ONONDAGA COUNTY DEPARTMENT OF PUBLIC WORKS
 DIVISION OF DRAINAGE AND SANITATION
METROPOLITAN SYRACUSE SEWAGE TREATMENT PLANT
 MECHANICAL
DIGESTER CONTROL HSE. BASEMENT PLAN

ONONDAGA COUNTY DEPARTMENT OF PUBLIC WORKS
 DIVISION OF DRAINAGE AND SANITATION
METROPOLITAN SYRACUSE SEWAGE TREATMENT PLANT
 MECHANICAL
DIGESTER CONTROL HSE. FIRST FLOOR PLAN

DIGESTER CONTROL HSE. SECOND FLOOR PLAN

EXISTING PLAN OF DIGESTER CONTROL
 HOUSE AT ELEV 369.00'
 Scale 1/4" = 1'-0"

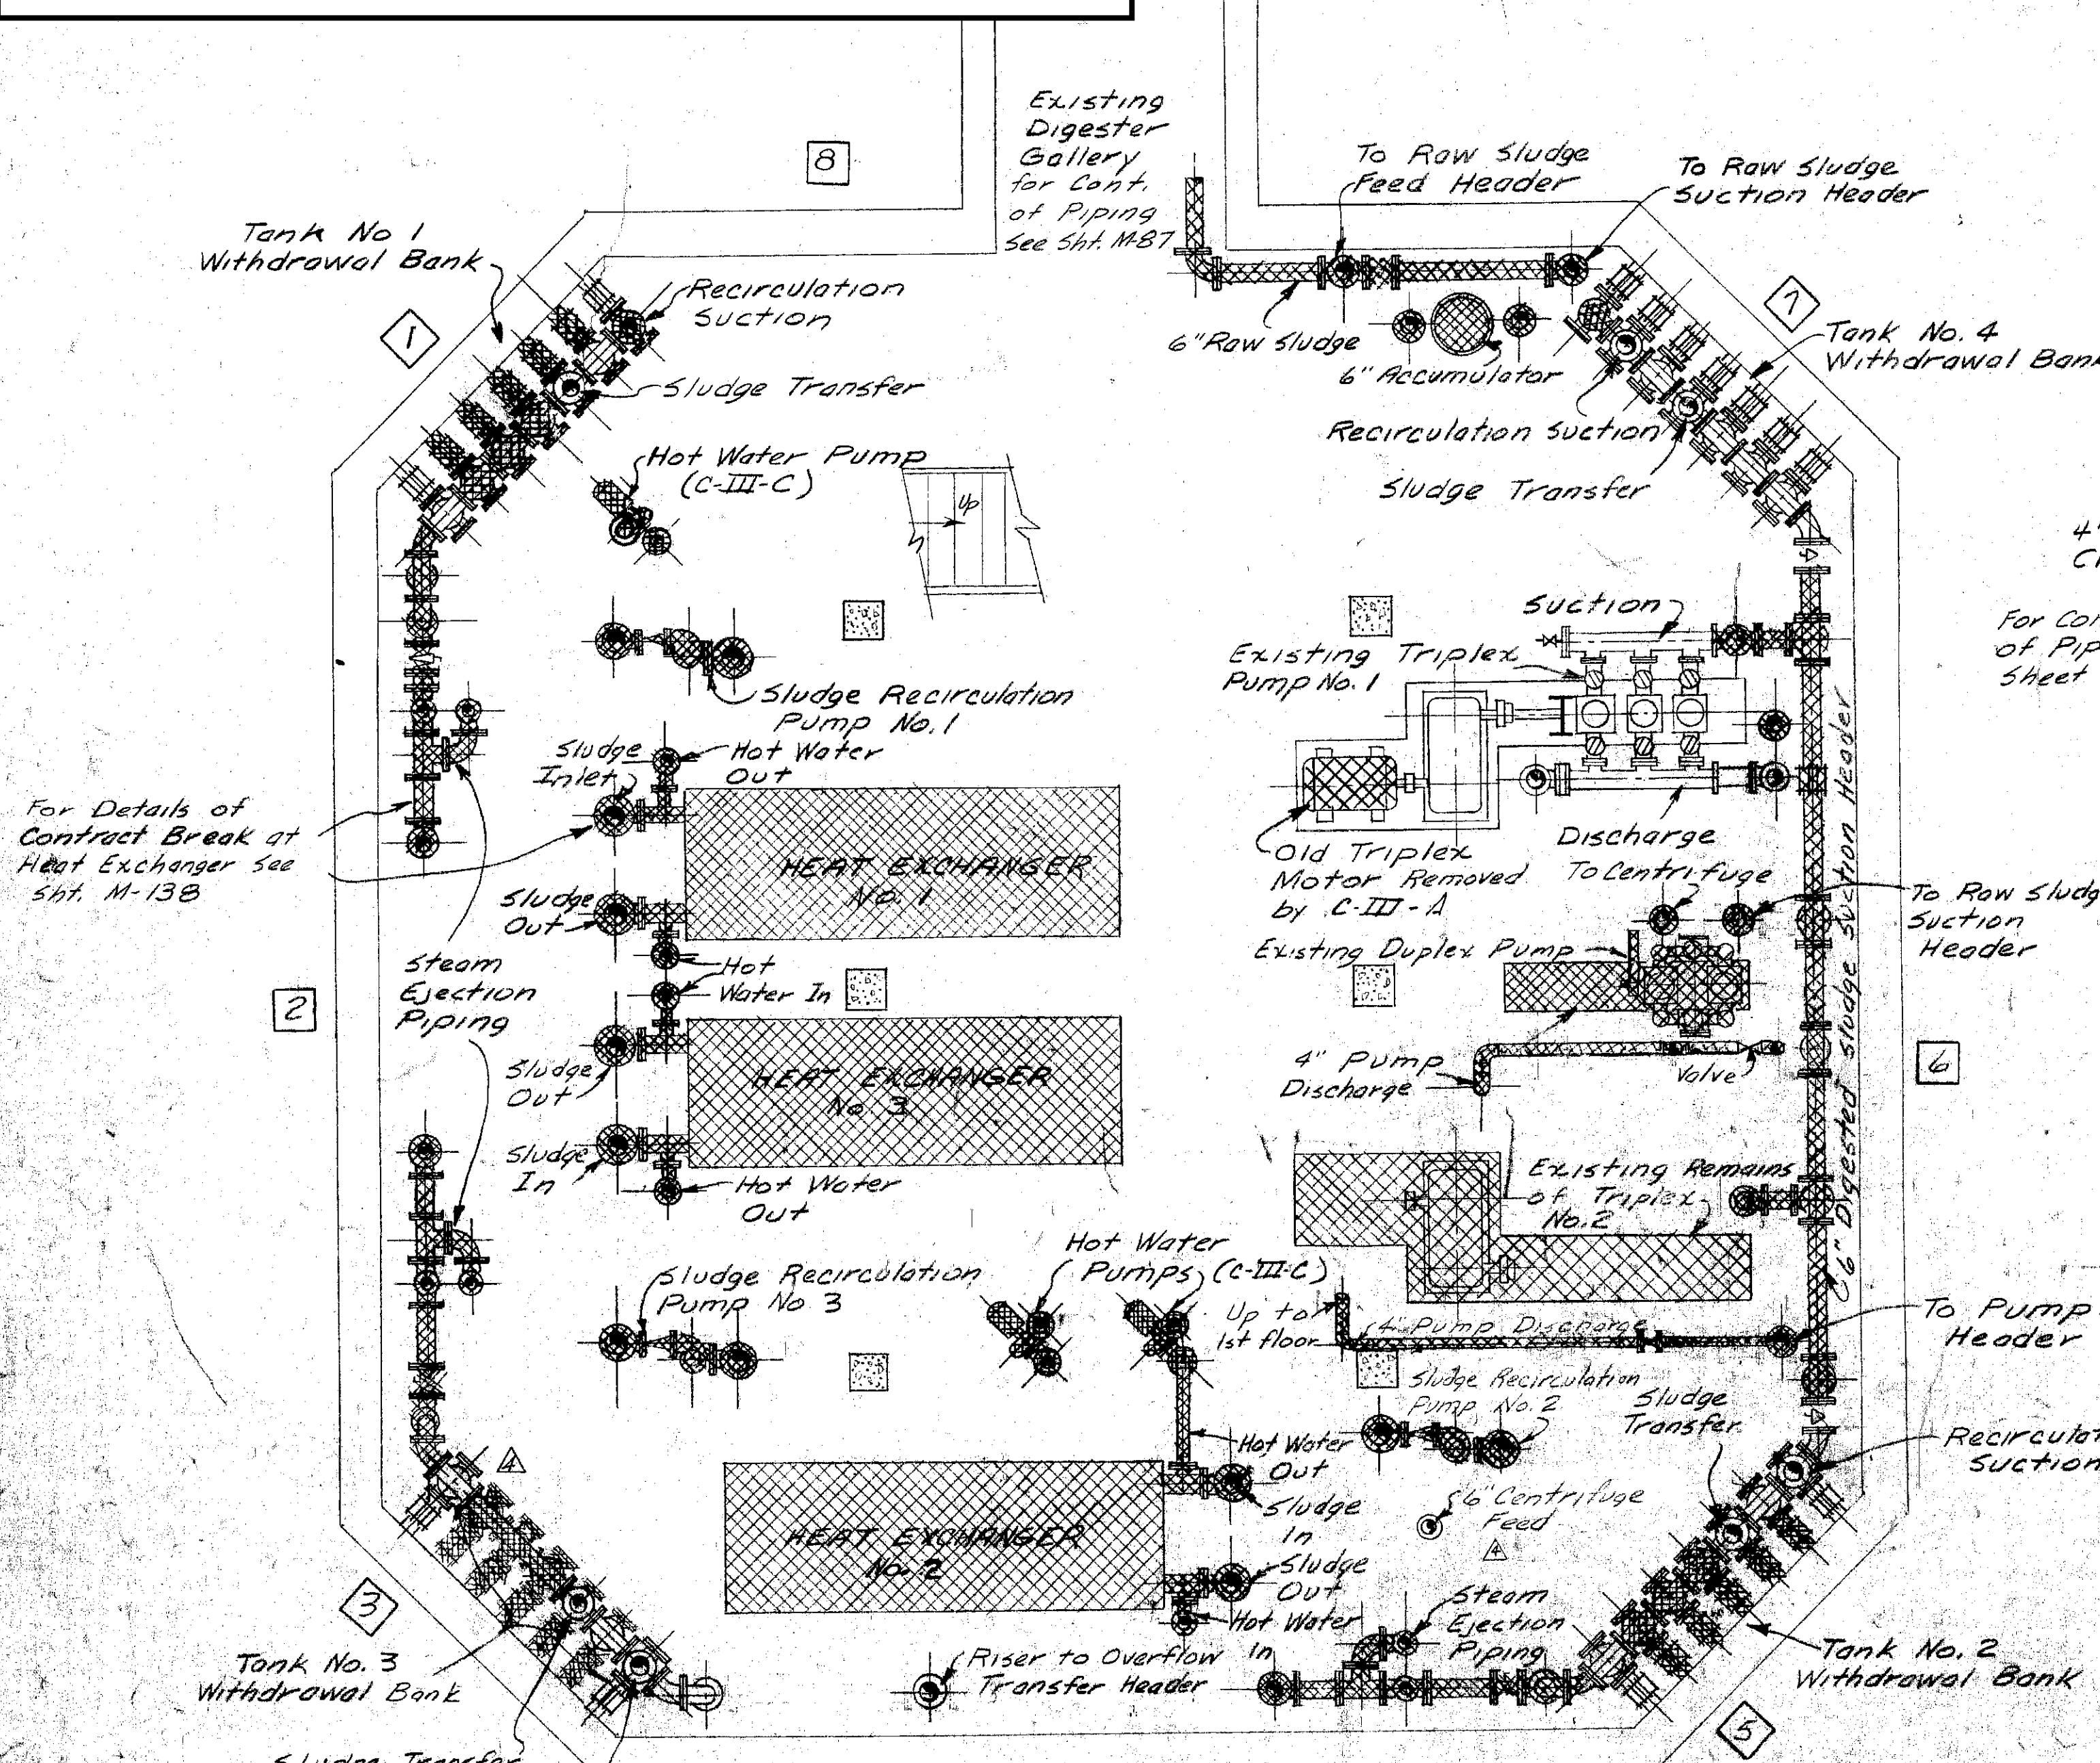
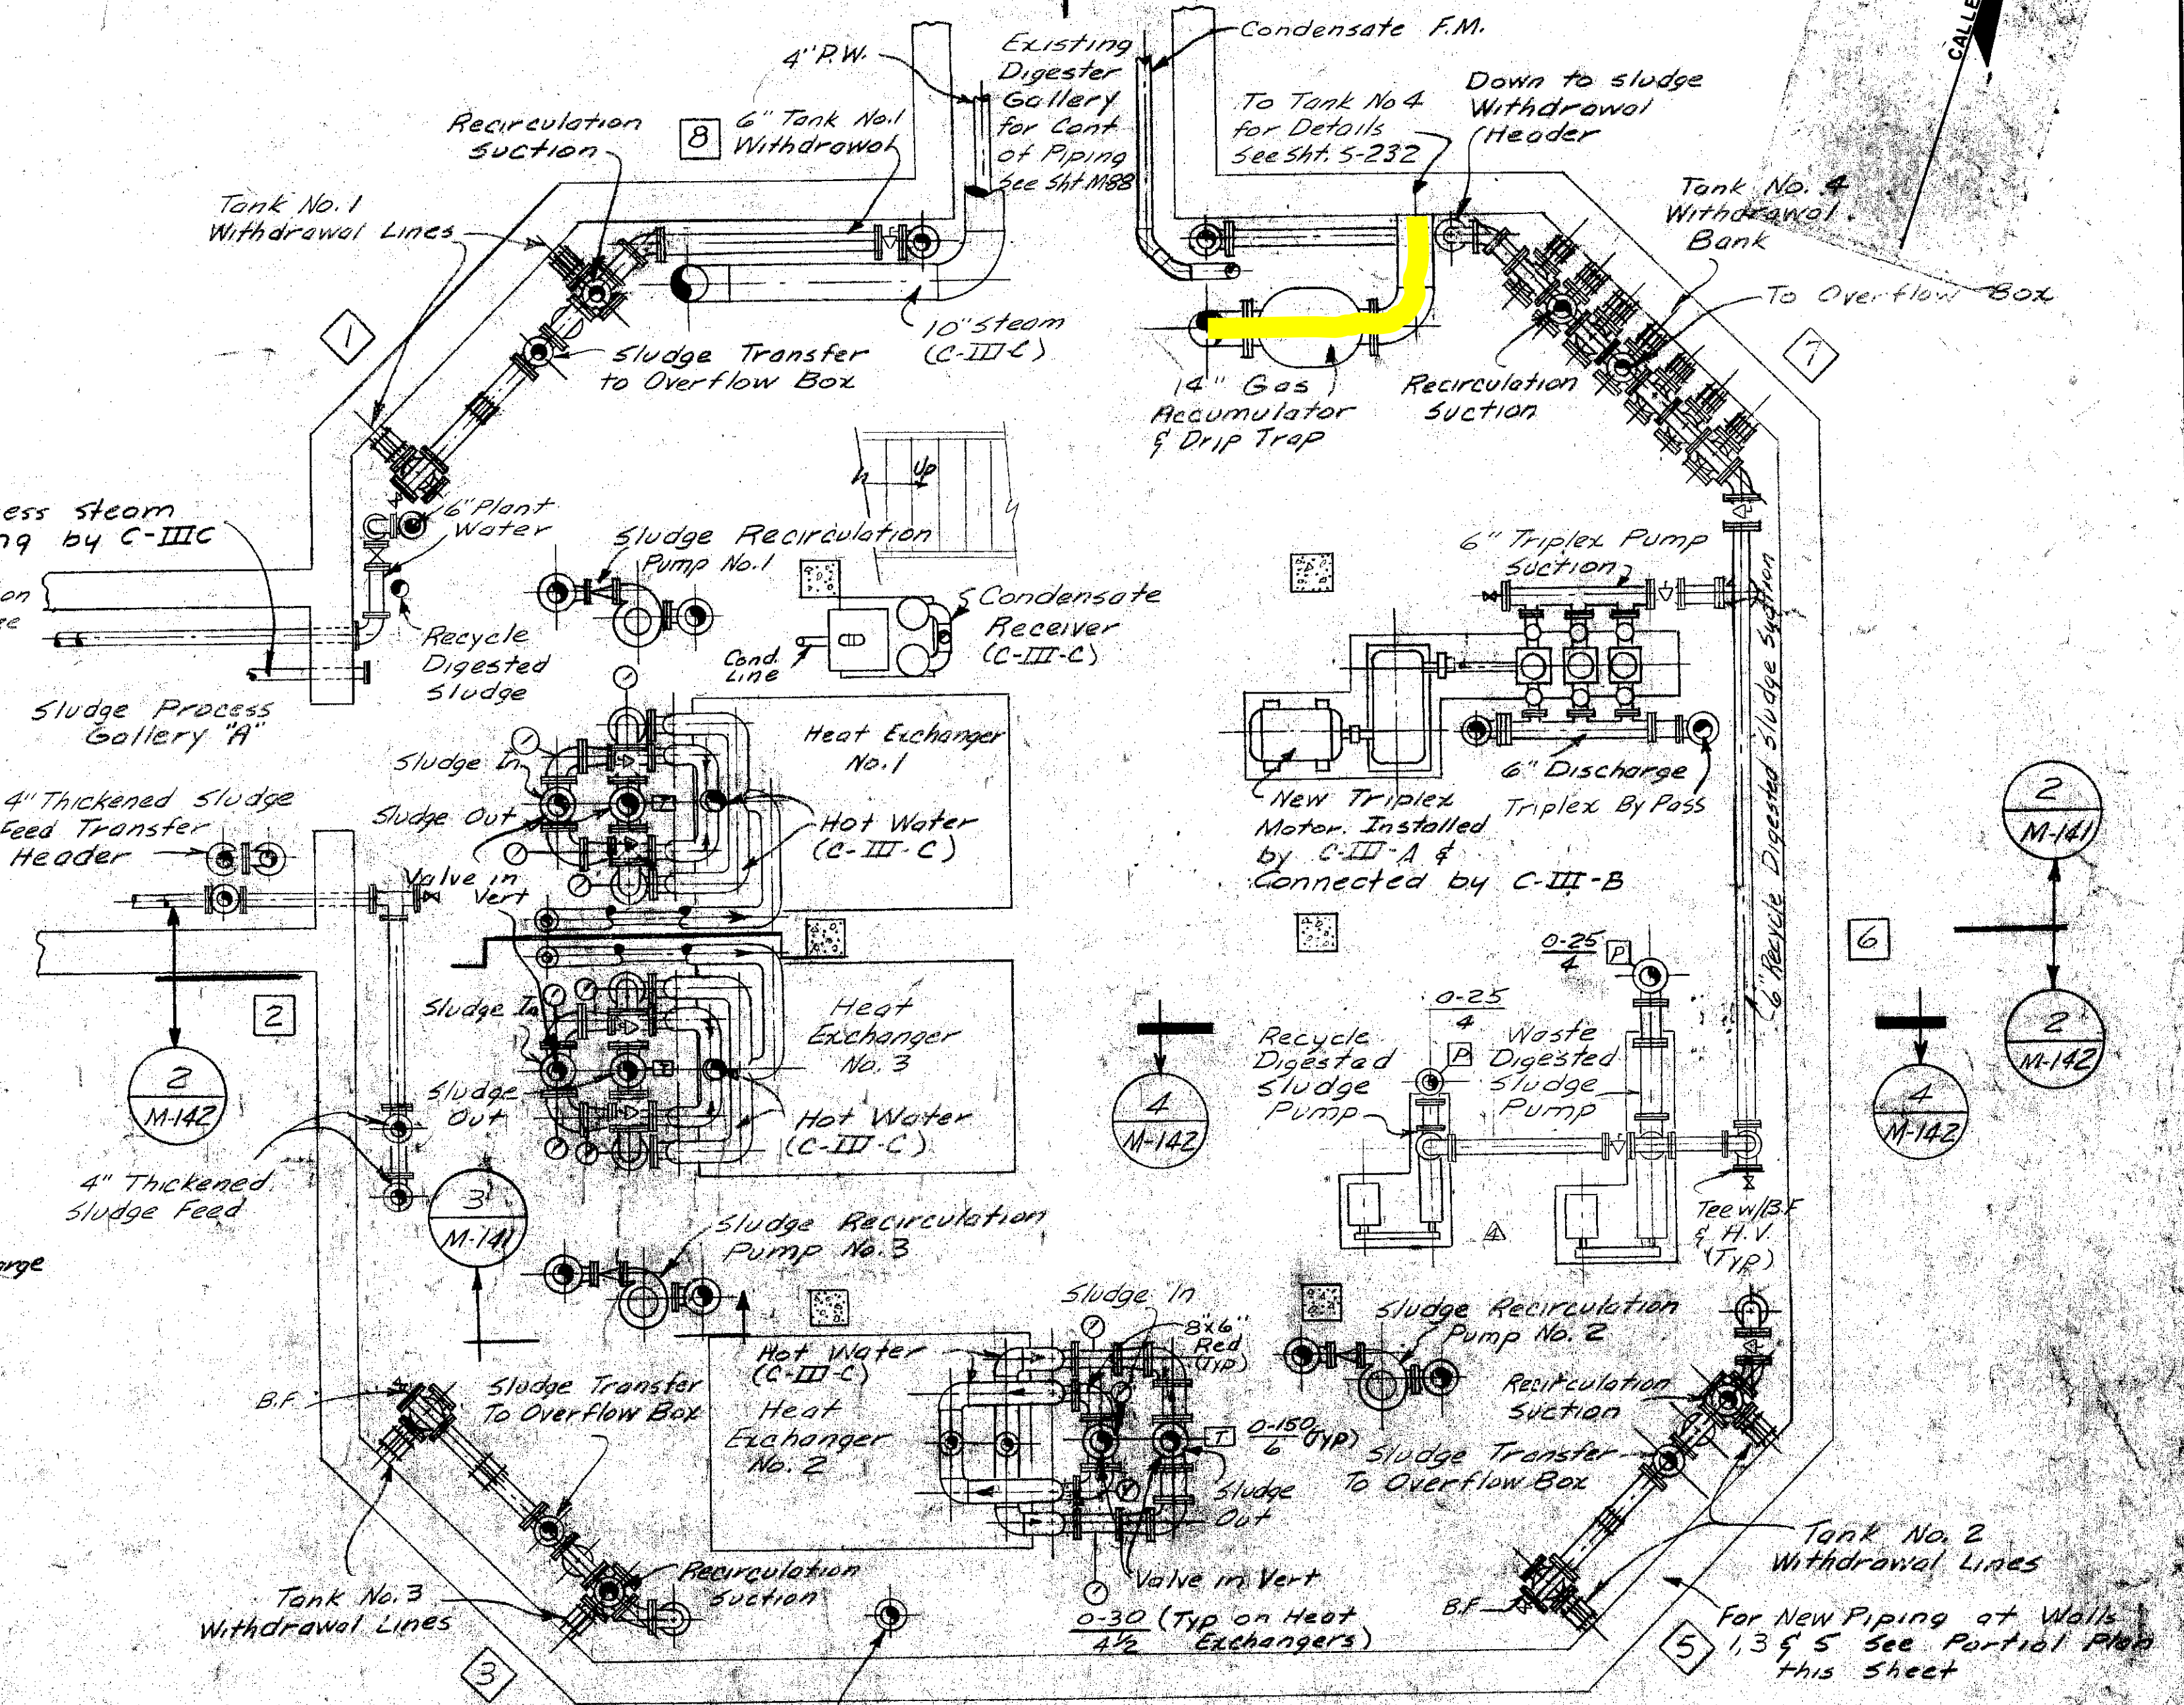
Need to be Replaced:
 Existing Stainless Steel:

PLAN OF EXISTING DIGESTER CONTROL
HOUSE AT ELEV 371.50'
 scale 1/4" = 1'-0"

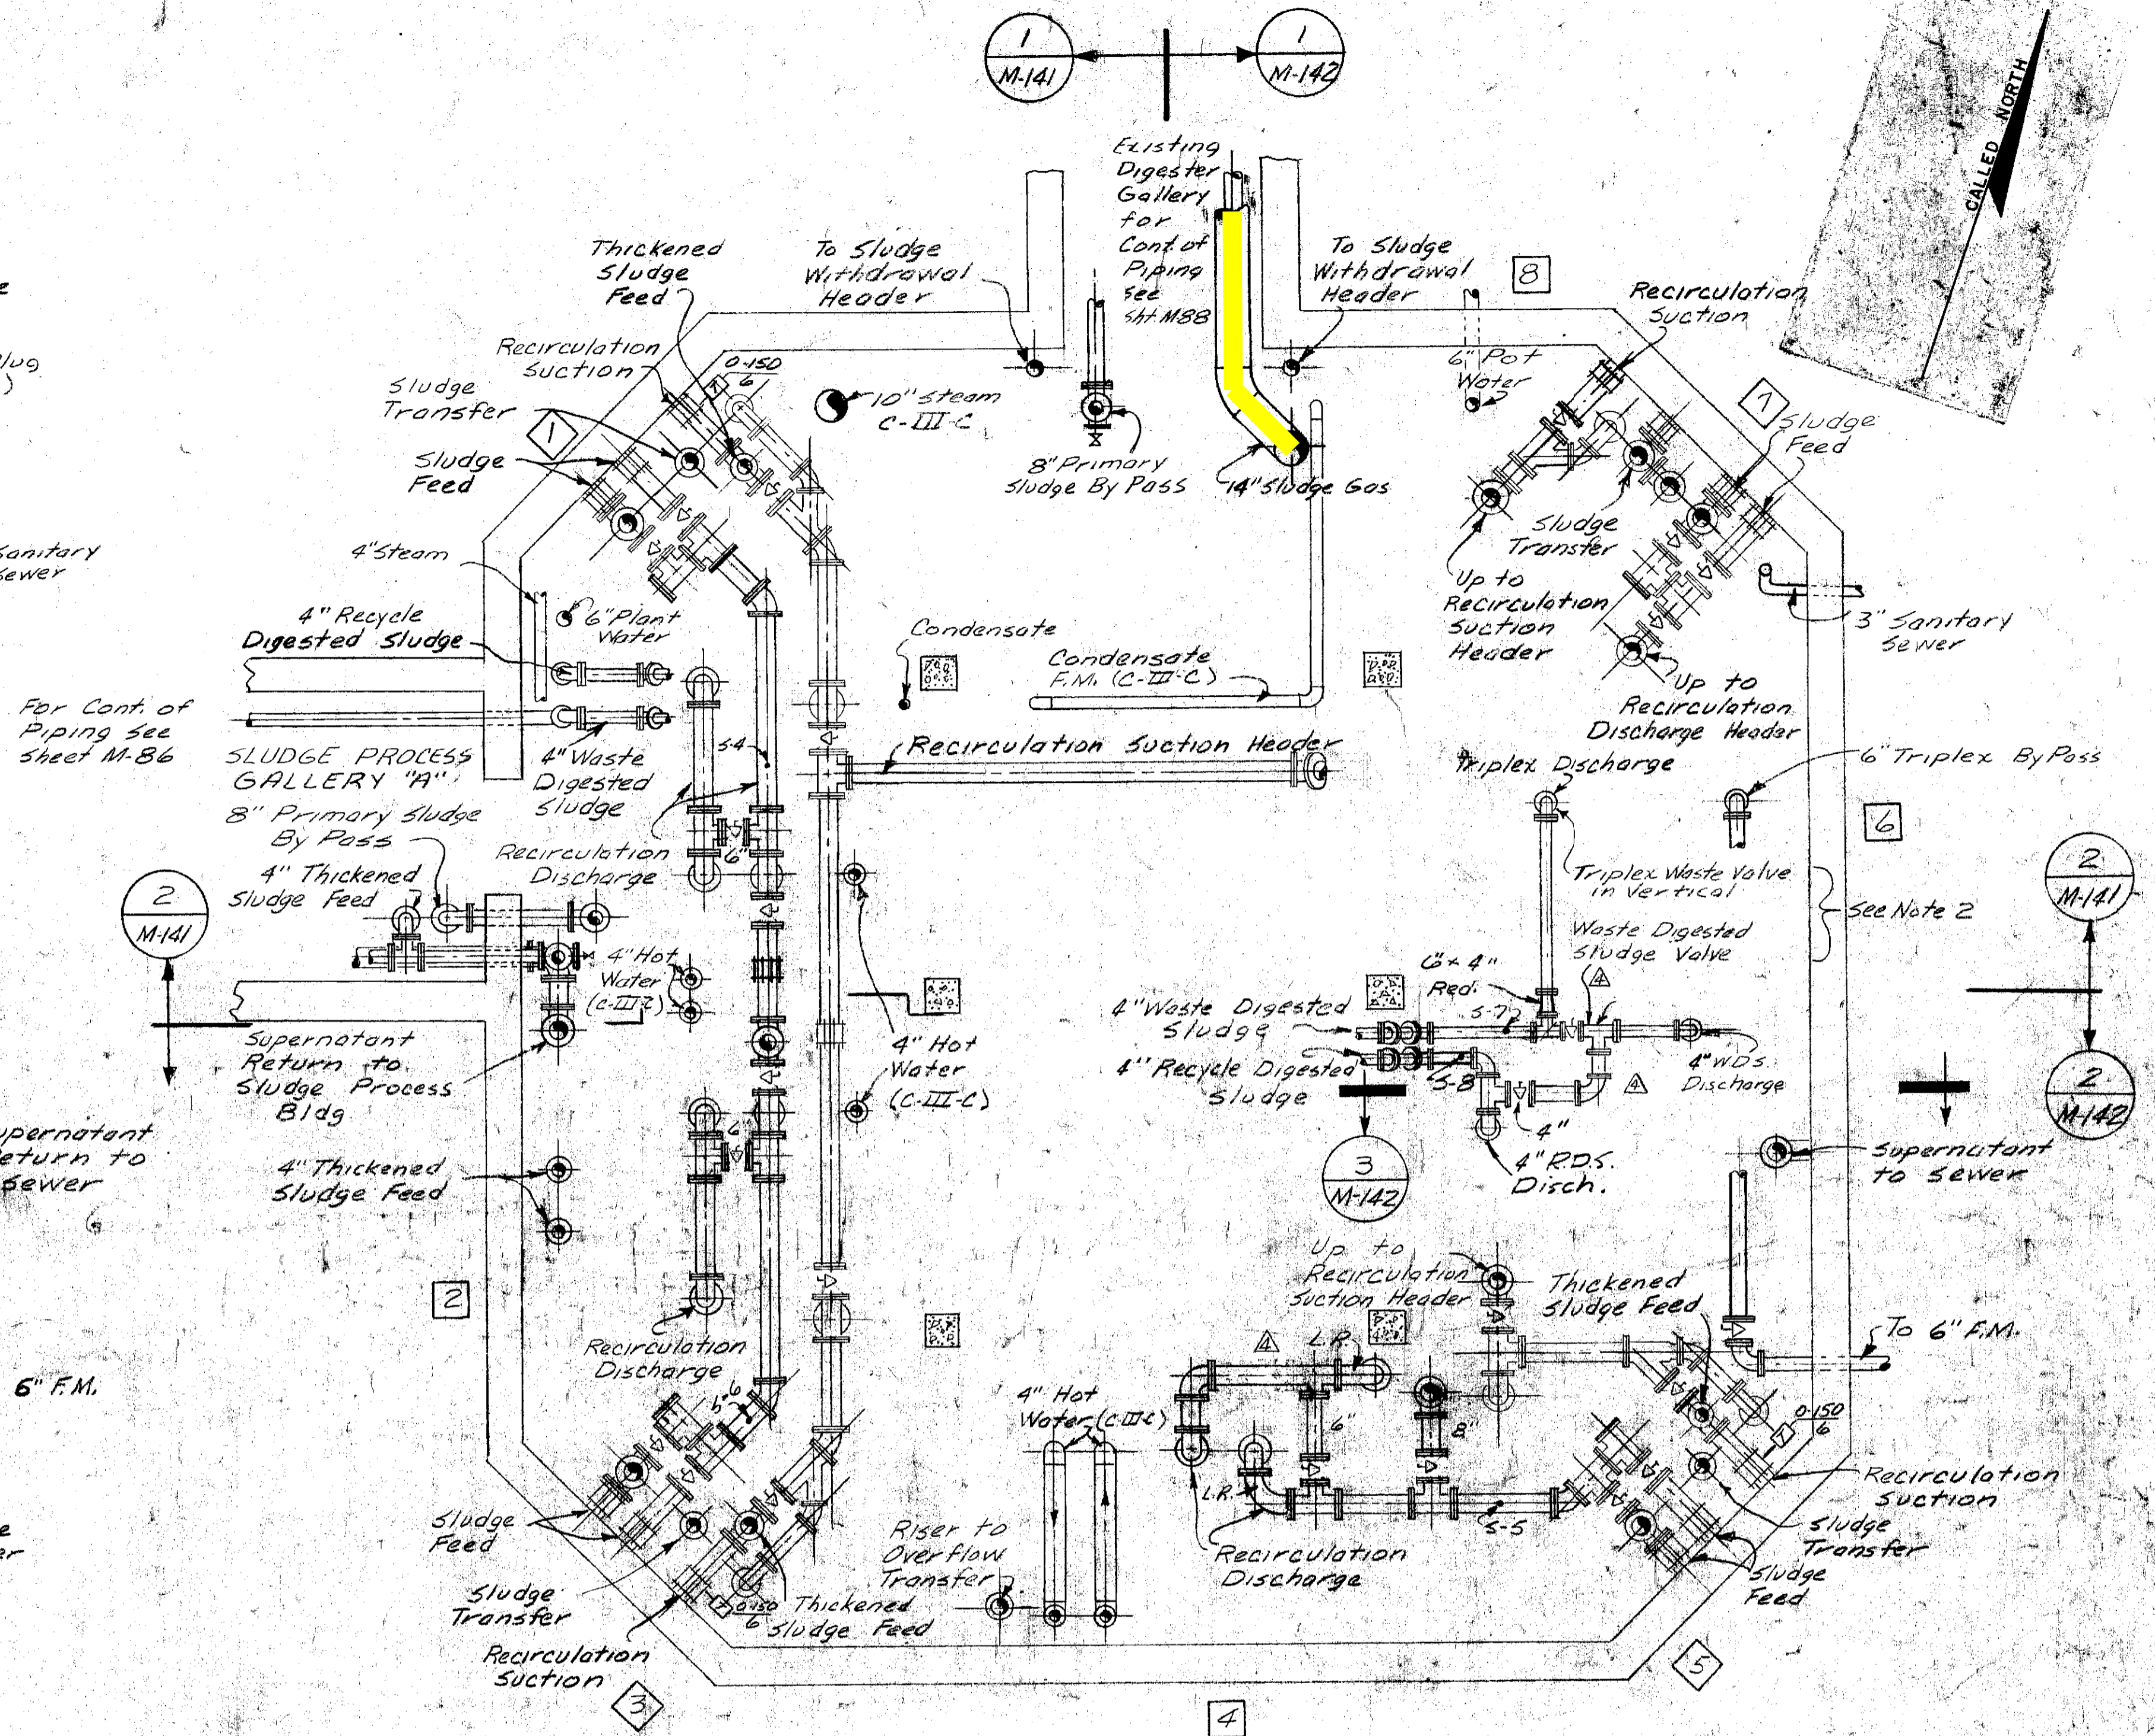
Need to be Replaced:
 Existing Stainless Steel:
